Compliance with EU Battery Regulations

MELQIC series

This technical bulletin informs you of the change in the MELQIC series batteries.

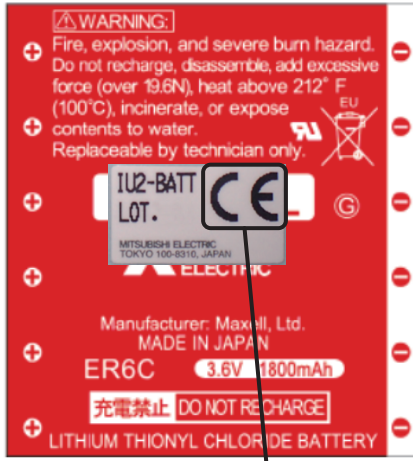
To comply with the EU Battery Regulations, the CE mark will be added on the target batteries.

The change has been applied to the products manufactured from June 2024 onwards.
